PŘÍKAZ K ZACHOVÁNÍ LETOVÉ ZPŮSOBILOSTI

Číslo: FAA AD 2011-10-09

Airworthiness Directives; Cessna Aircraft Company Models 150, 152, 170, 172, 175, 177, 180, 182, 185, 188, 190, 195, 206, 207, 210, T303, 336, and 337 Airplanes

ACTION: Final rule.

Figure 1. Diameter of seat pin locking engagement hole

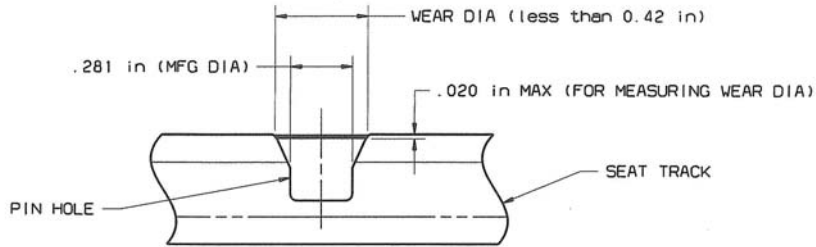
Dave McFarlane requested we add a maximum allowable incremental 0.07-inch radius dimension to figure 1 at the outside diameter dimensions for clarification.

We disagree with this comment. The measurement dimensions in figure 1 adequately address the measurements necessary for this AD. Additional measurements will not provide any additional benefit.

We have not changed this final rule AD action based on this comment.

Figure 4. Closeup of seat roller housing and tang gap width

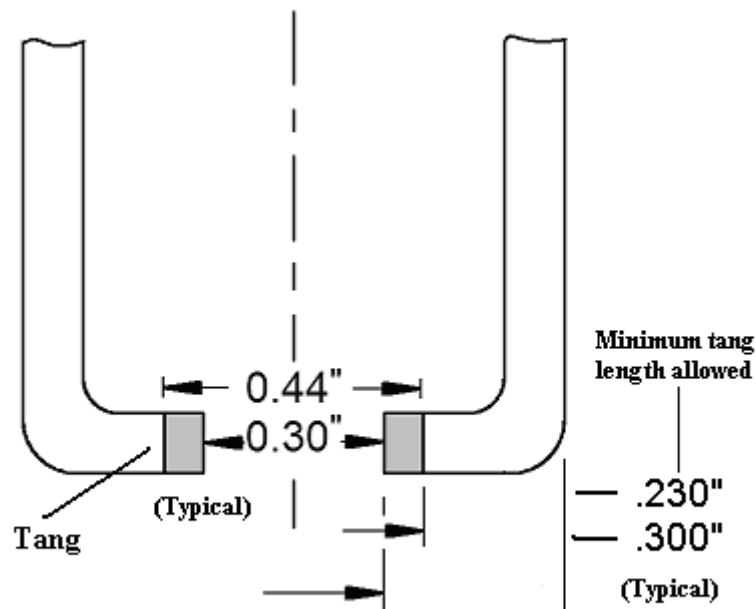
Brian A. Andrus, Jim Currie, and Jerry Unruh requested we change the tang measurement to the outside of the seat roller housing and change the description of the tang measurement. This change would make it easier for the inspector to take the measurement and to better understand what is being measured.

We agree with this comment. We agree that measuring the tang length inside of the roller housing is difficult because of the presence of the rollers inside of the roller housing.

We have changed the callouts in figure 4 to measure the tang length from outside of the roller housing instead of from inside of the roller housing. We have also changed the description of the tang measurement in figure 4 to more accurately describe the measurement.
